WLTP-25-04e

Proposal for amendments to ECE-TRANS-WP29-GRPE-2019-02e

The text reproduced below was prepared by the IWG on Worldwide harmonized Light vehicles Test Procedure (WLTP). The modifications to the current text of Amendment 5 of GTR 15 are marked in bold for new or struck through for deletion.

Annex 6, Figure A6/6, amend to read:

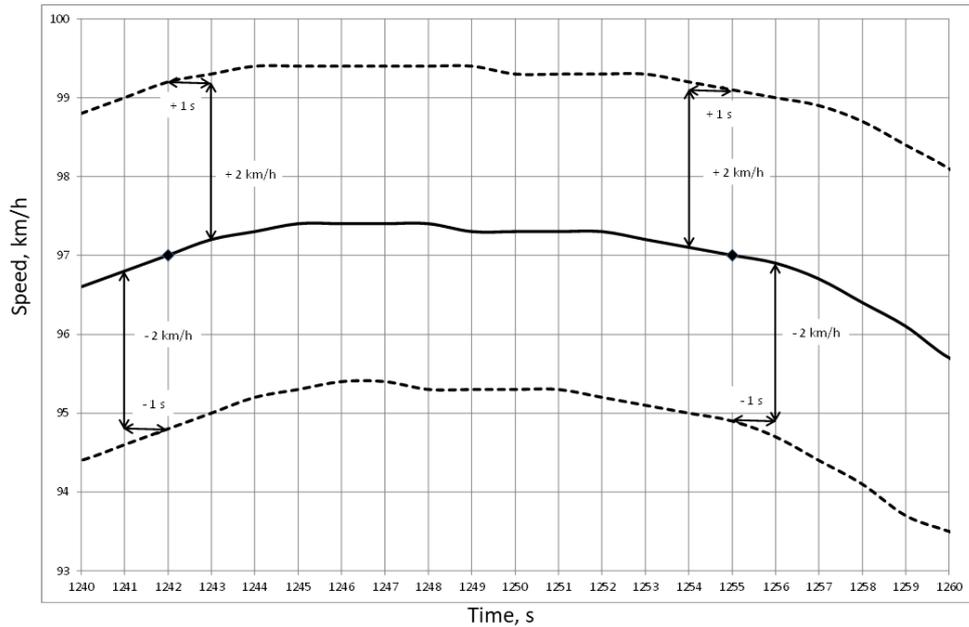
Correction/justification: The original diagram did not have x and y axes labeled.
